LUSCOMBE AIRPLANE CORPORATION  
P.O. Box 2128, Dallas 1, Texas

TO: All Silvaire Owners & Operators  
FROM: Service Department, Luscombe Airplane Corp.  
SUBJECT: Inspection of 18432 Rudder Horn  
SERIAL NOS. AFFECTED: 1934-5724

SERVICE LTR. 5-12-48

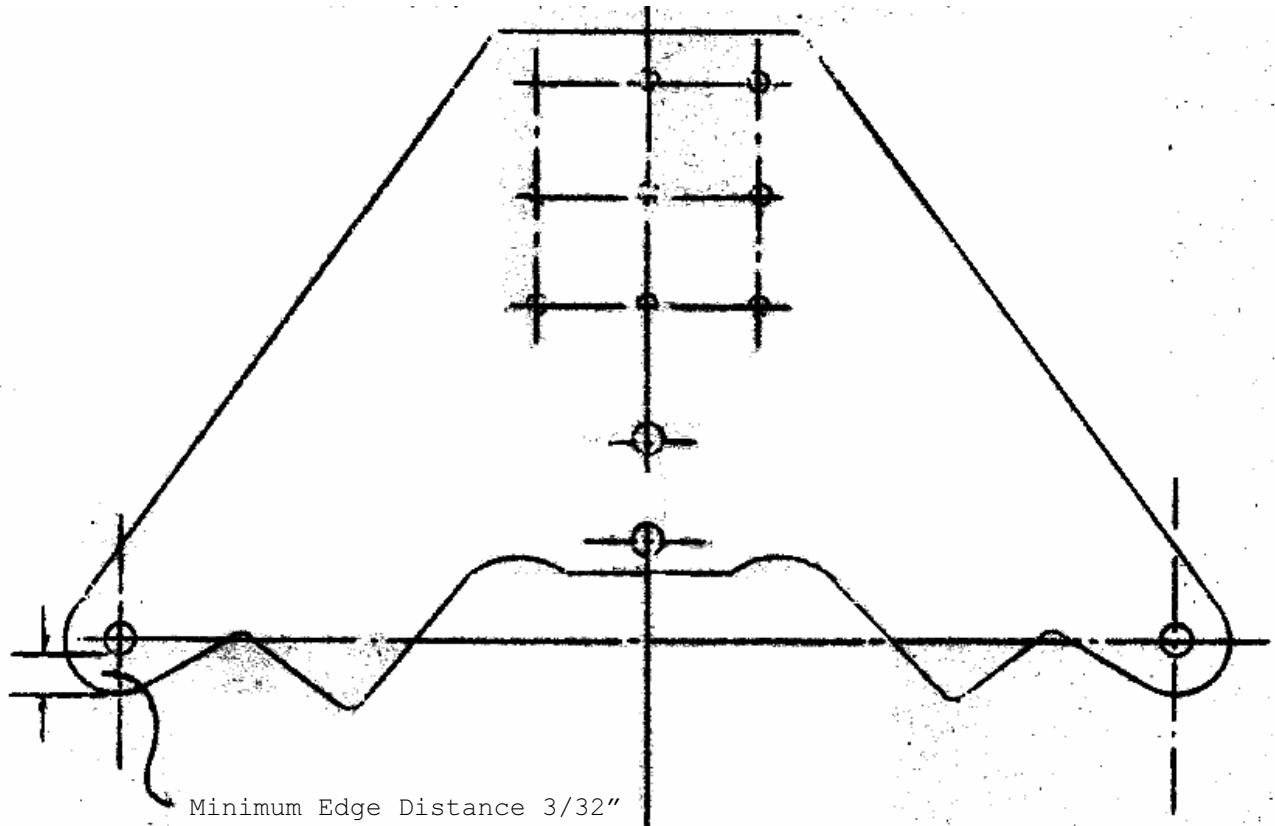
Several cases of excessive wear and elongation of eyebolt attachment holes in the rudder horn have been reported to the factory.

In all cases the subject aircraft have from 500-600 total hours operation at time of discovery of this condition.

All aircraft should be checked at each one hundred hour inspection for excessive wear at this point, minimum allowable edge distance being 3/32". (See attached sketch)

Marginal cases discovered upon inspection may be corrected by adding two rudder arm extensions, part number SK4149. These parts may be procured through the Service Department.
